**Figure 1. New Circuit Board (Typical)**

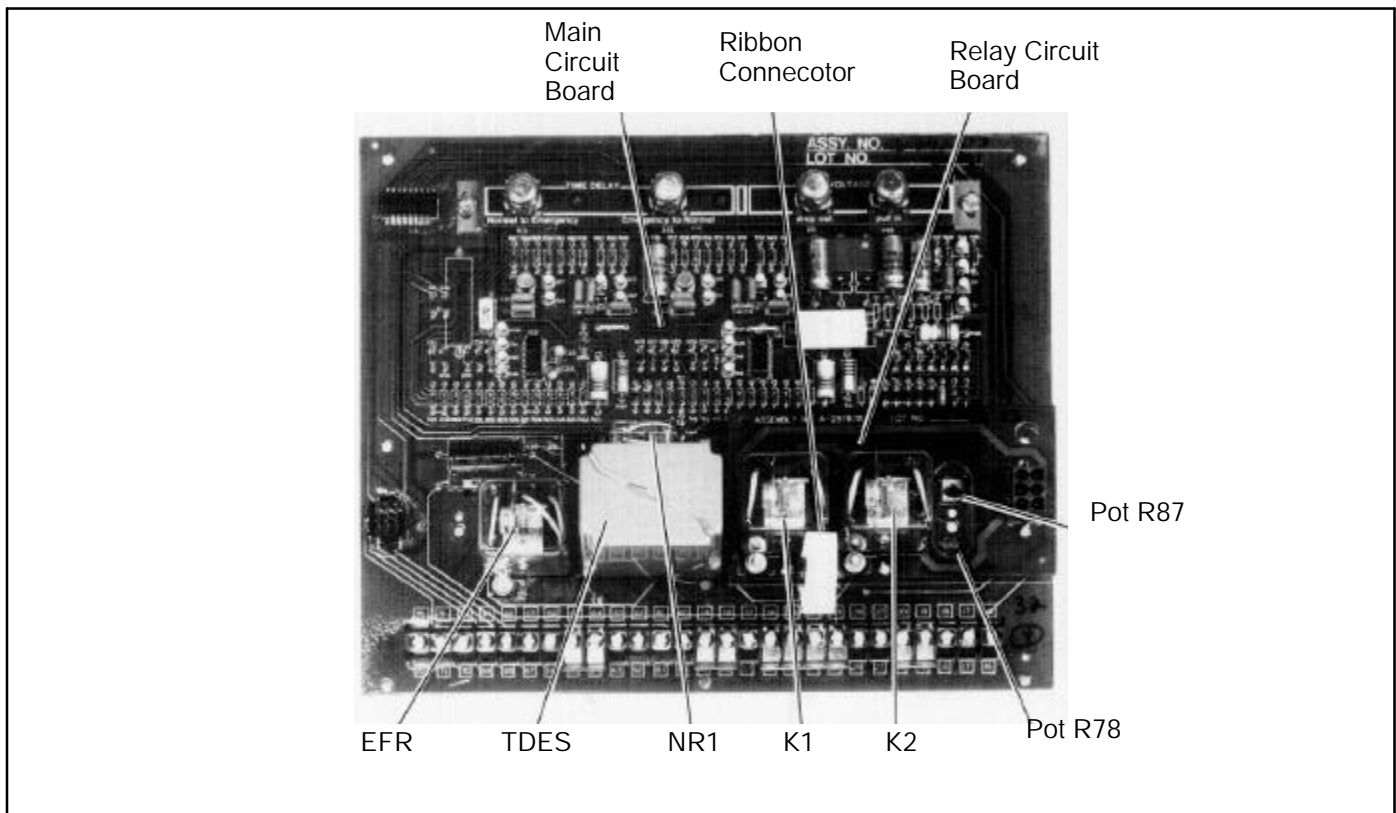
EFR relay 295318 (12 vdc) replaces relay 295254 (12 vac) on A-circuit boards. These relays are not interchangeable.

Relays (EFR, TDES, NR1, K1 and K2) are serviceable individually. Test and replace the components before replacing the circuit board.

Potentiometers R78 and R87 were calibrated at the factory and should not be adjusted. Do not tamper with these settings.
